PREVOST

SAFETY RECALL

Sr09-10

DATE : JUNE 2009	SECTION : 14-STEERING
SUBJECT : INSPECTION AND REPLACEMENT OF DRAG LINK SPHERICAL PLAIN BEARING ROD END

FIGURE 4

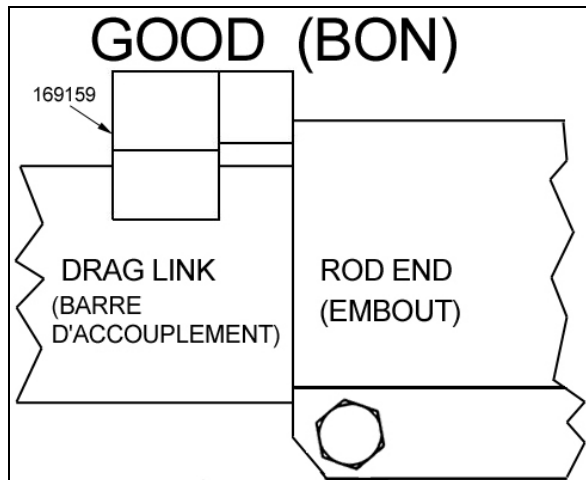
1. Raise vehicle in order to inspect already installed parts.
2. Clean drag link surface near the rod end and also spherical plain bearing rod end to ensure proper measurements (Refer to figure 3)
3. Use supplied go/no-go gauge (169159) to check wall thickness of the drag link spherical plain bearing rod end located near front L.H. side wheel without having to remove drag link. **Minimum wall thickness is 4 mm (0.158 inch or 5/32")**. While resting go/no-go gauge against drag link, if you can get the gauge completely on the rod end up to 10 mm (3/8") from the rod end extremity, rod end must be replaced (Refer to figures 3, 4 and 5).

NOTE
<i>Control thin sections of rod end.</i>

4. If measurement is outside tolerances, part 610991 must be replaced.

FIGURE 6

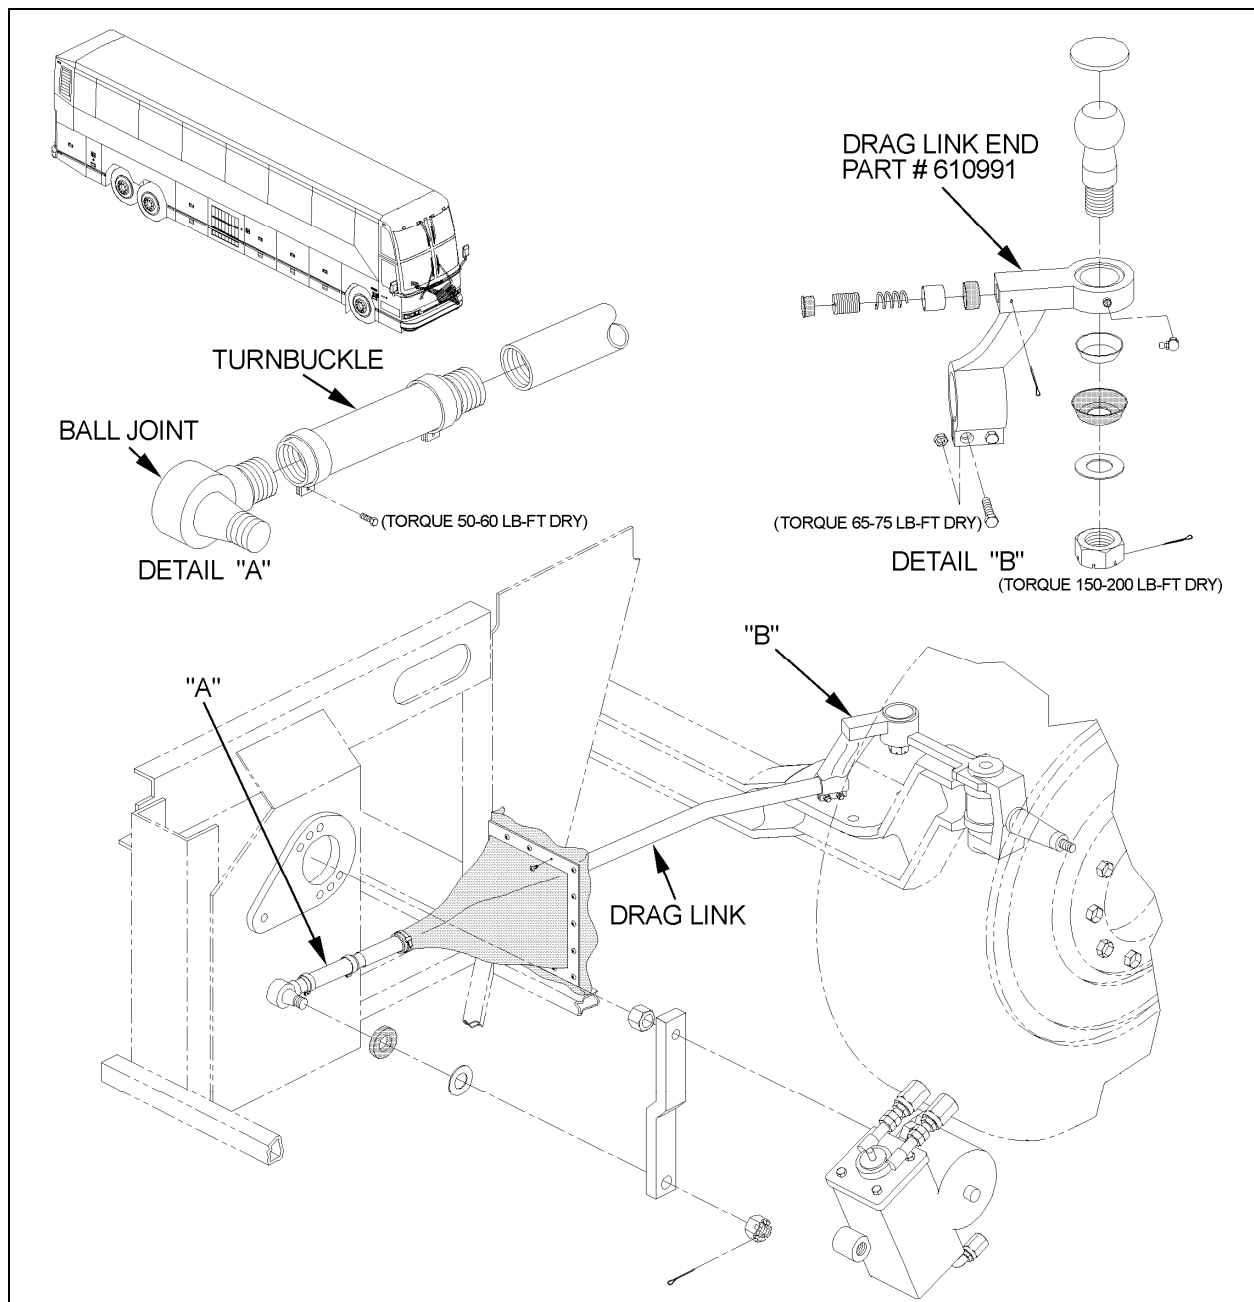
1. At drag link spherical plain bearing rod end remove cotter pin from castle nut then remove castle nut.
2. Separate L.H. steering arm from ball joint.
3. Unfasten two pinching bolts from drag link end.
4. Unfasten drag link end from drag link (Refer to figure 6).

5. Install new drag link end (610991). Fasten drag link end onto drag link the same number of turns as previously removed.

Prior to new drag link end installation, apply some anti-seize (680335) into the rod end opening and onto drag link threads to facilitate future removal.

6. Reconnect steering arm to ball joint, torque tighten castle nut to 150-200 lb-ft dry.
7. Install new cotter pin (502104).
8. Torque tighten two drag link end pinching bolts to 65-75 Lb-Ft dry.
